Subject: Bid Package #1
Borel Middle School HVAC Replcmt-DSA 01-119557
College Park Elementary School HVAC Replcmt-DSA 01 119530
Meadow Heights Elementary School HVAC Replcmt DSA 01-119554
North Shoreview Montessori School HVAC Replcmt DSA 01-119526
San Mateo - Foster City School District

ADDENDUM NO. 1

Subject: Borel Middle School HVAC Replacement
San Mateo - Foster City School District
Aedis Project No. 2021005
DSA Application #01-119557

ADDENDUM NO. 1

DATE 11/24/2021
JOB # **2021005.07**
SHEET # **AD-1
E3.1**

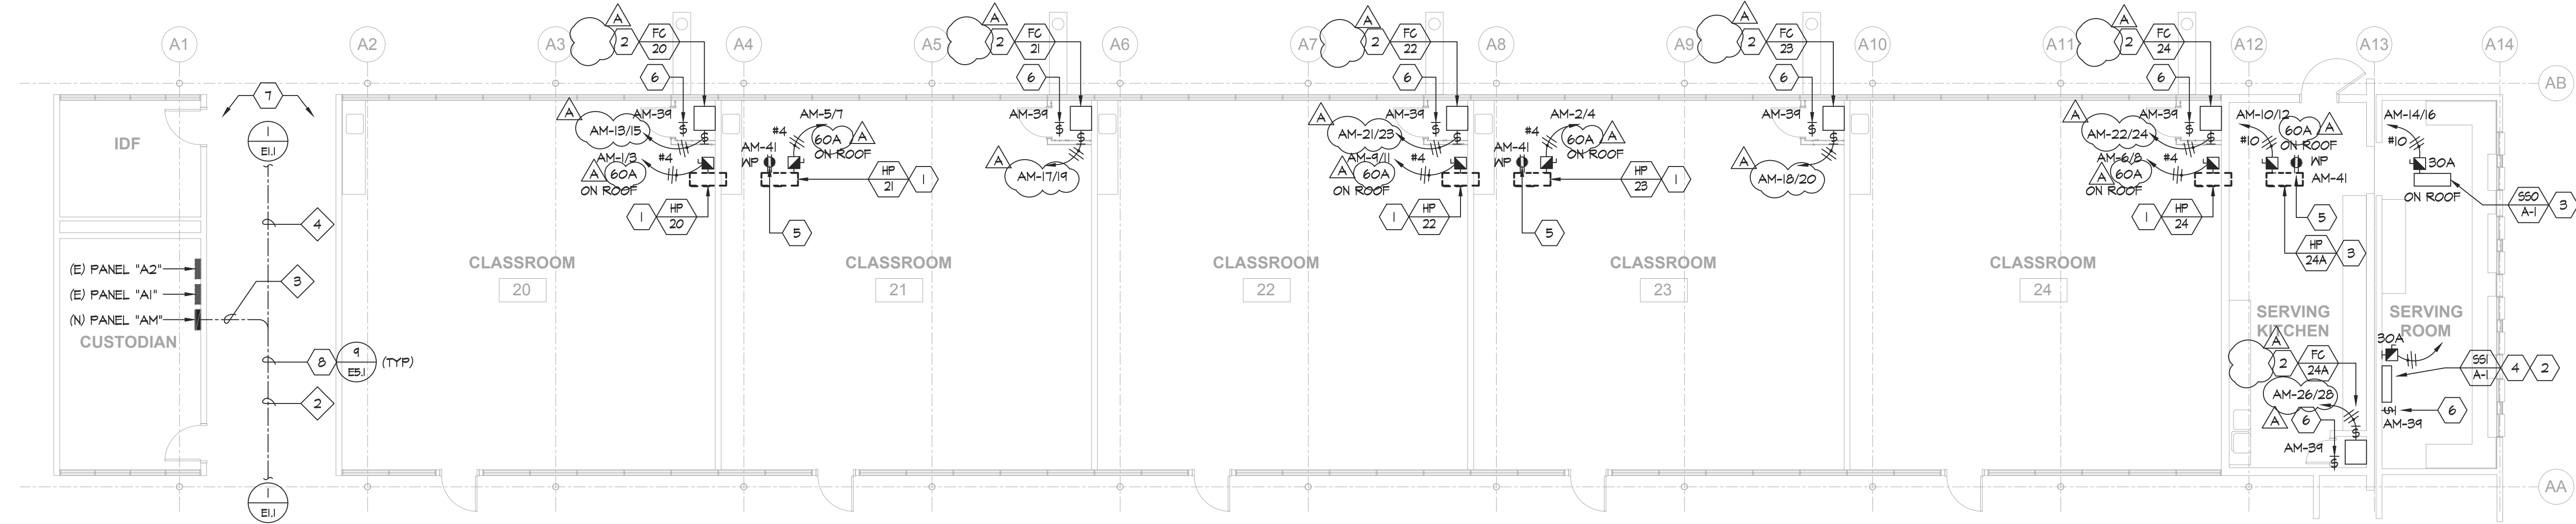
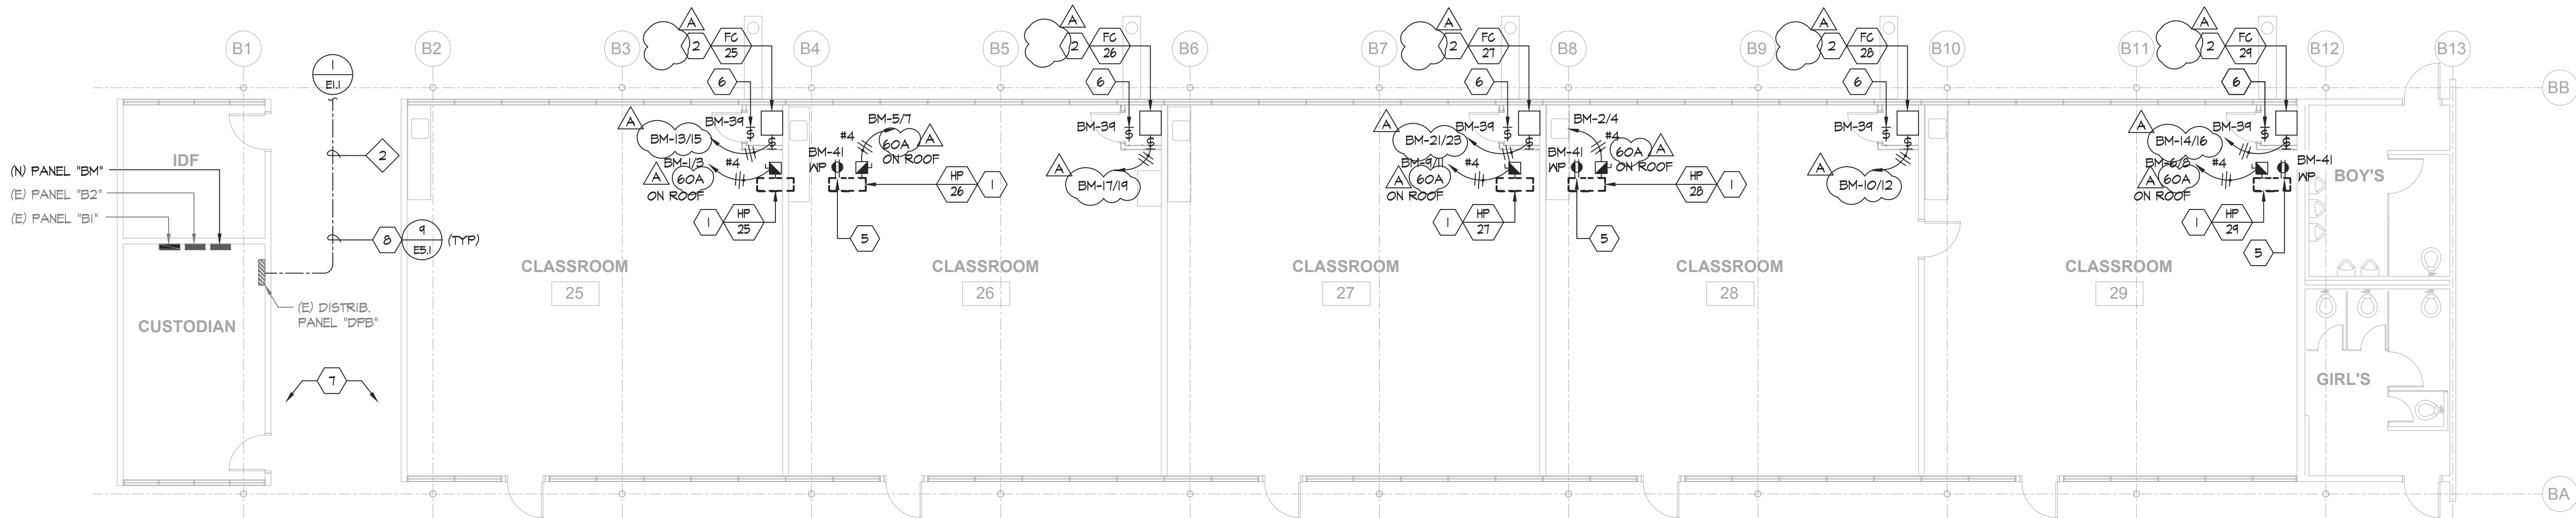
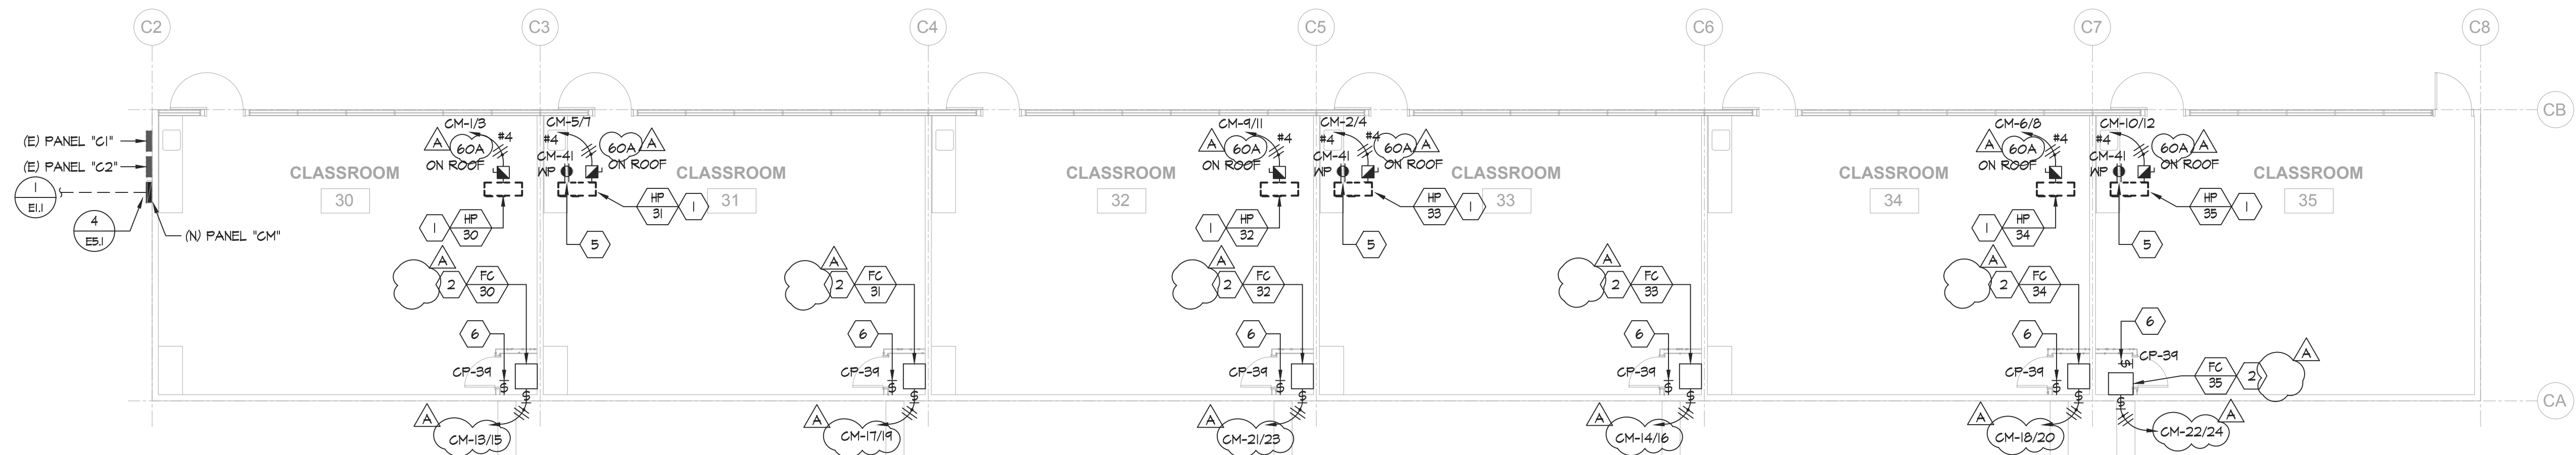
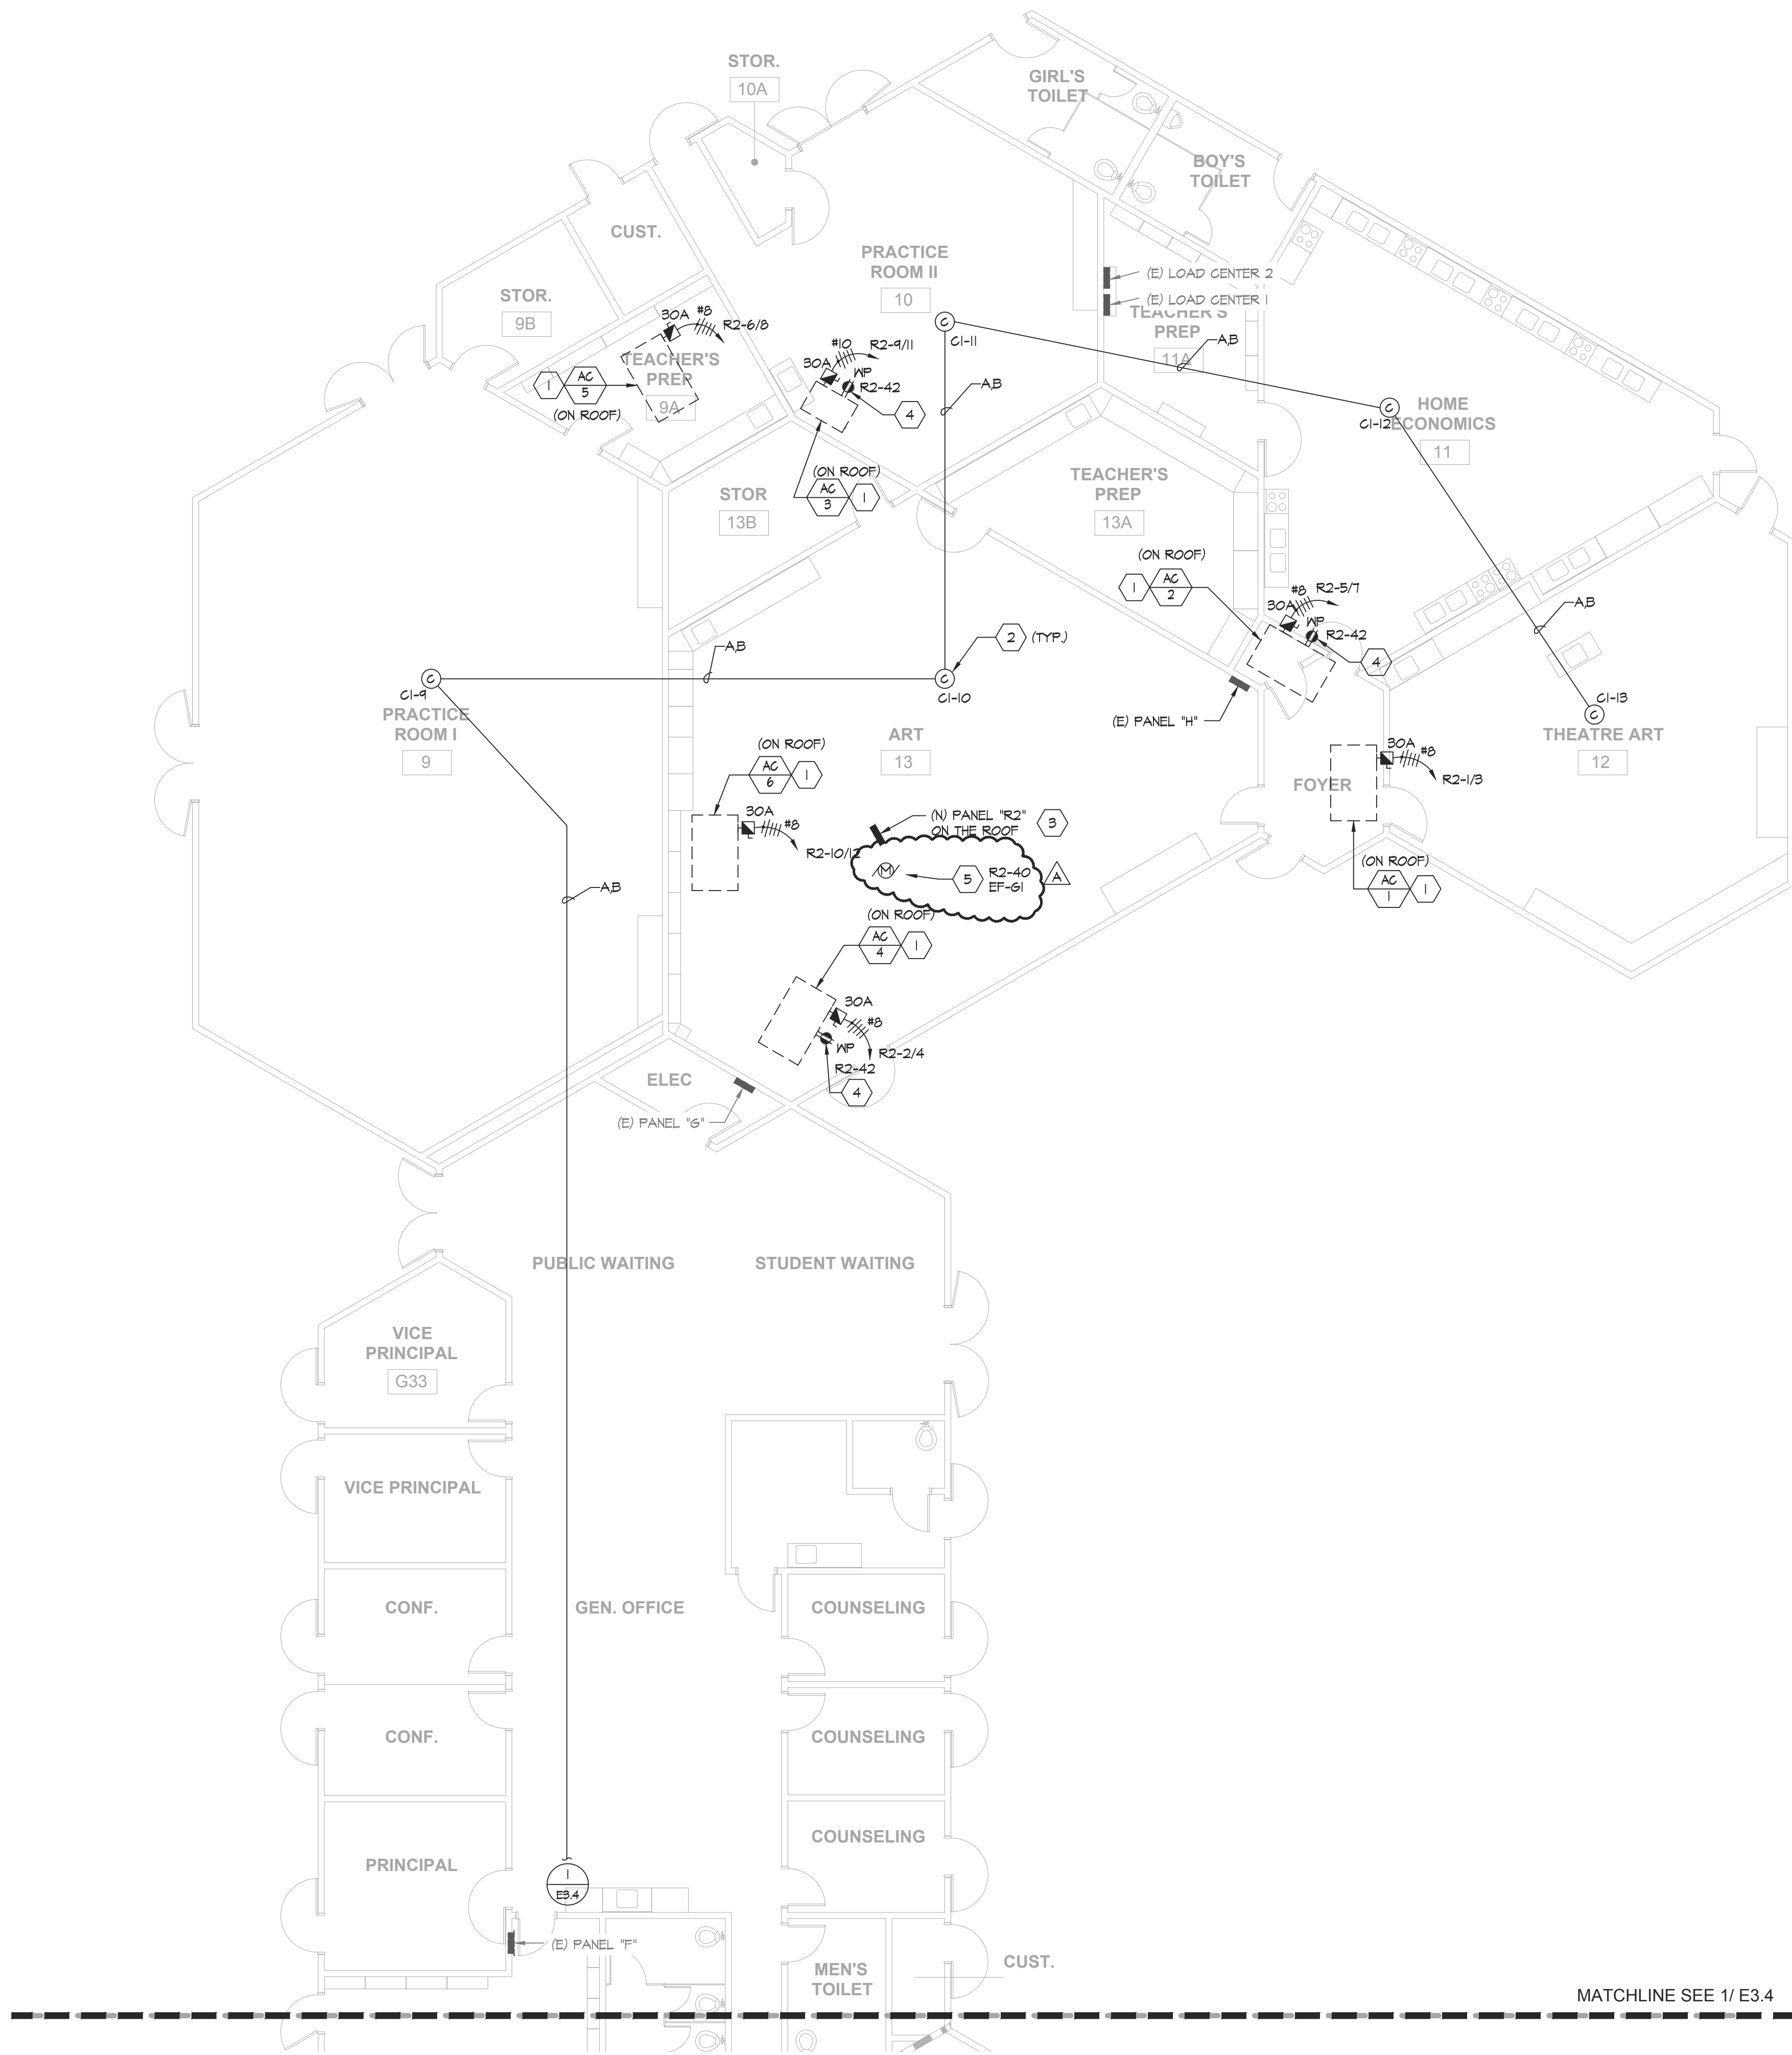
Add: General Notes #6, as shown clouded on AD1-E3.1

Revise: Electrical plans 1/E3.1, 2/E3.1, 3/E3.1 & 4/E3.1 per AD1-E3.1

DATE 11/24/2021
JOB # 2021005.01
SHEET # AD1-A1.02

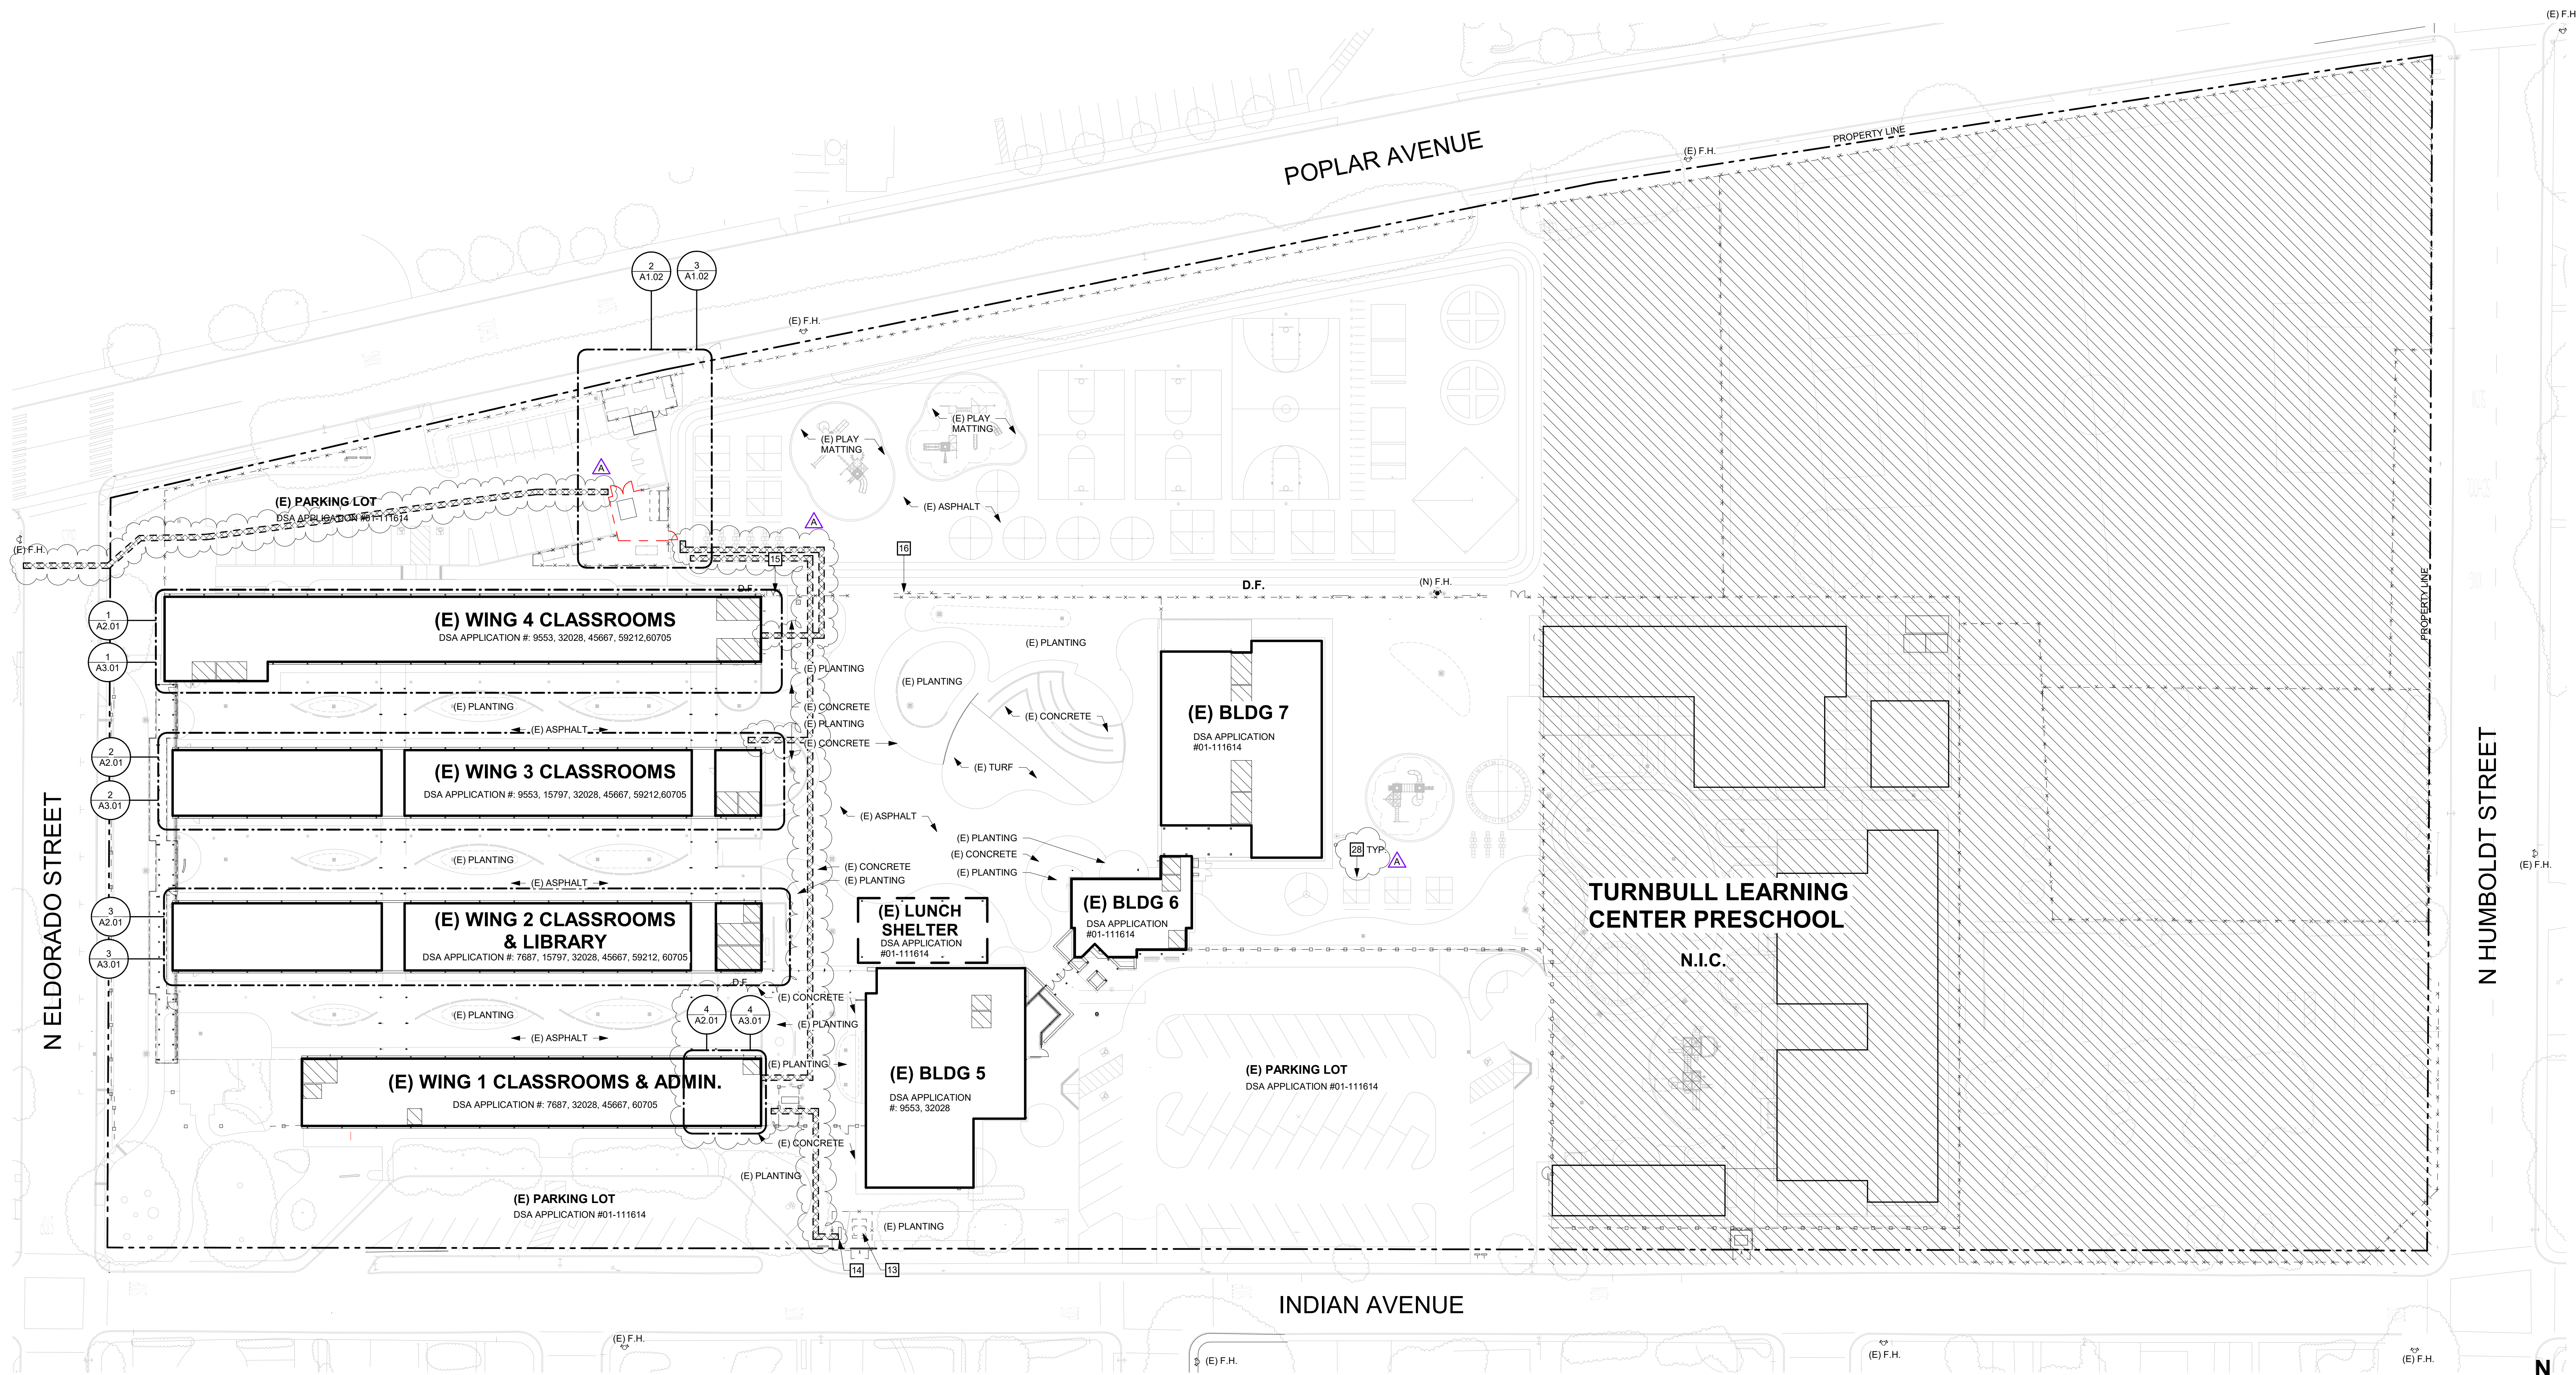
- Add: Trench area to New Site Plan 1/A1.02 & Graphic Key per AD1-A1.02
- Revise: General Notes #G as shown per AD1-A1.02
- Add: Keynote #28 to New Site Plan 1/A1.02 per AD1-A1.02
- Add: Enlarged plan call outs to 4/A2.01 & 4/A3.01 in New Site Plan 1/A1.02 per AD1-A1.02
